AMENDMENT NO. 1
(A Major Amendment)
California Endangered Species Act
Incidental Take Permit No. 2081-2019-048-06
Mesa Wind Power Corporation
Mesa Wind Repower Project in Riverside County

This Major Amendment No. 1 (Amendment) makes the following changes to the existing ITP:

Major Amendment No. 1
Incidental Take Permit 2081-2021-048-06
MESA WIND POWER CORPORATION
Mesa Wind Repower Project

Figure 1
Decommissioning
Restoration Areas

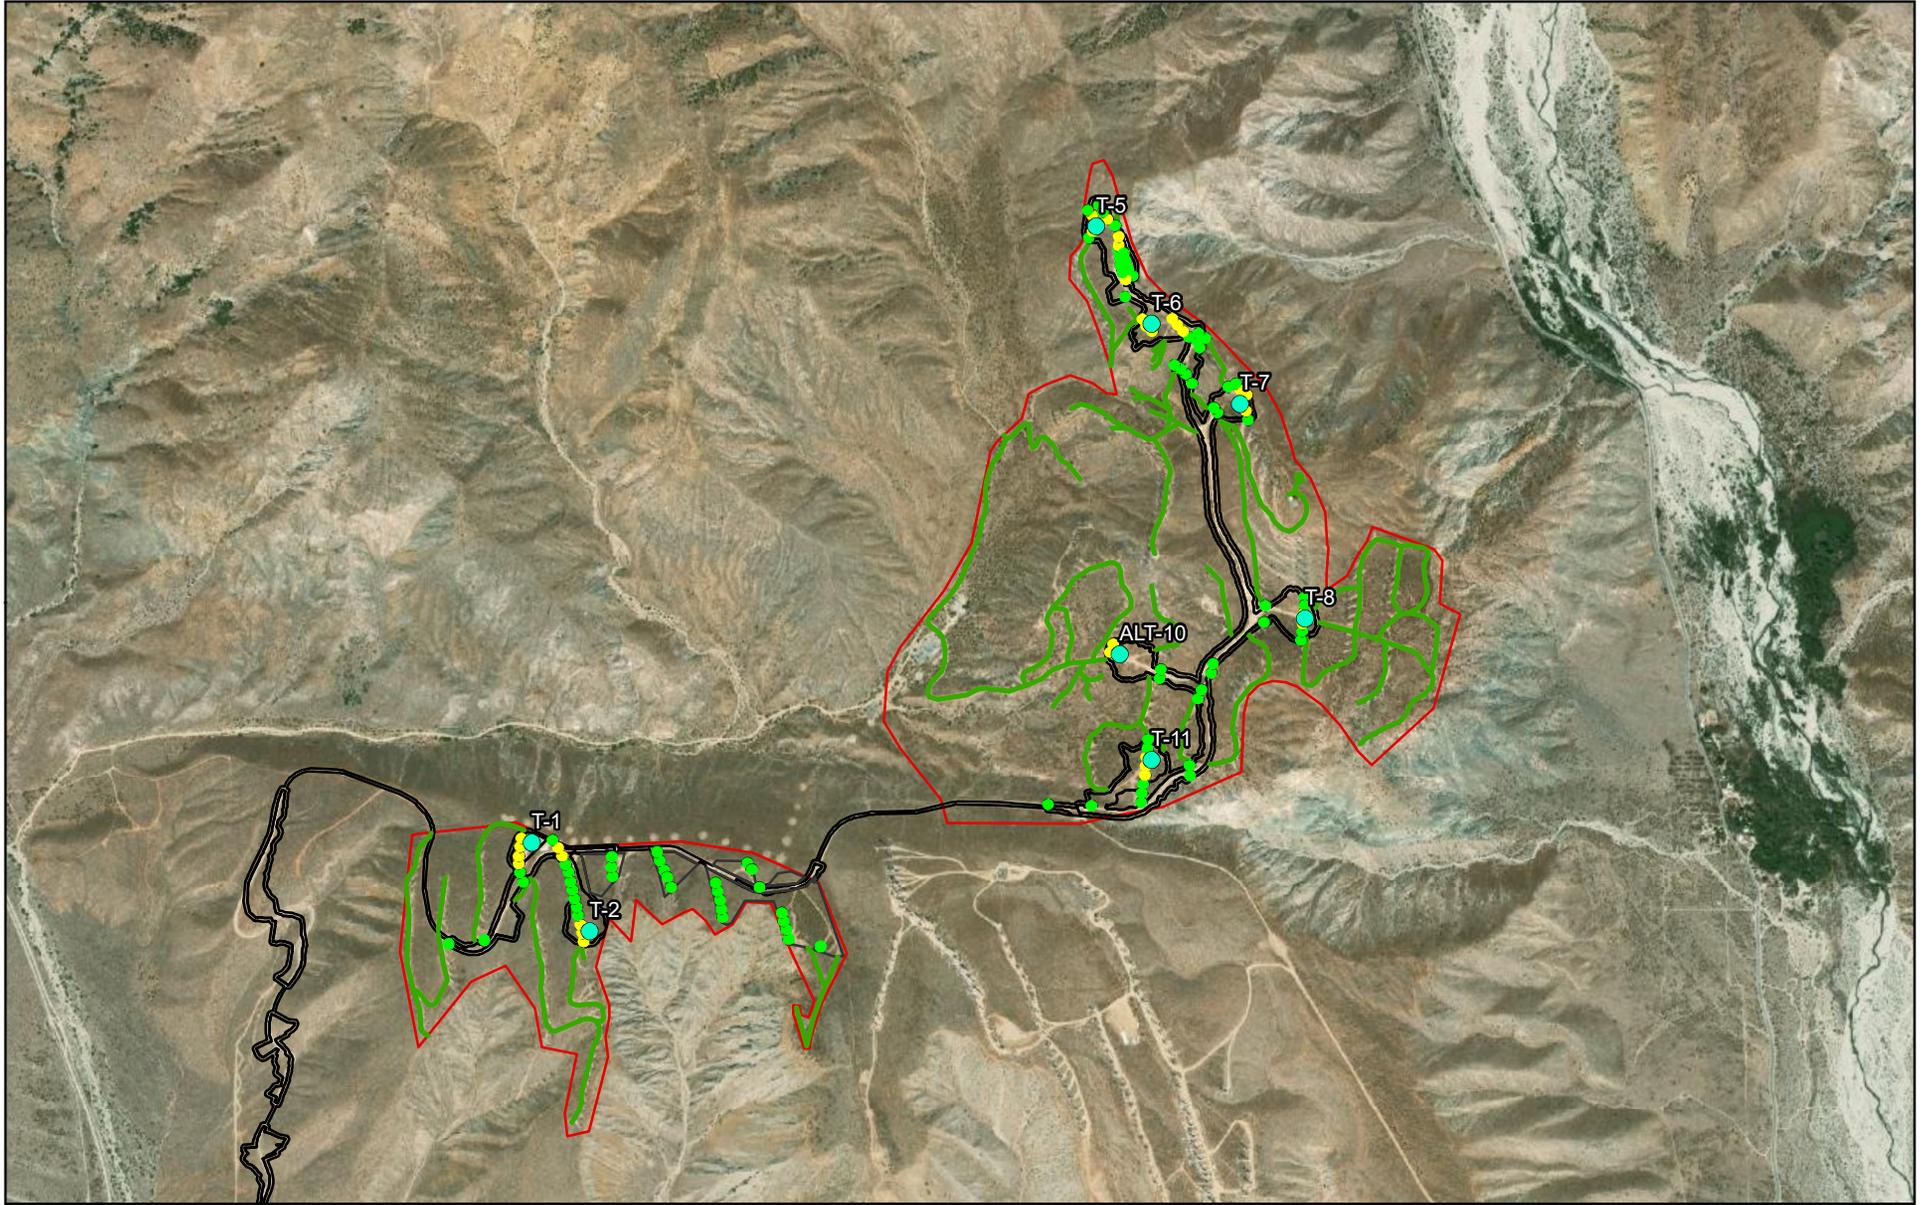
First, this Amendment will add the decommissioning of 460 legacy turbines and the restoration of the roads and pads within an additional 17.4 acres as a covered activity.

Discussion: This Amendment reflects a change in the acreage of impacts to the Covered Species by 17.4 acres through the decommissioning of an additional 346
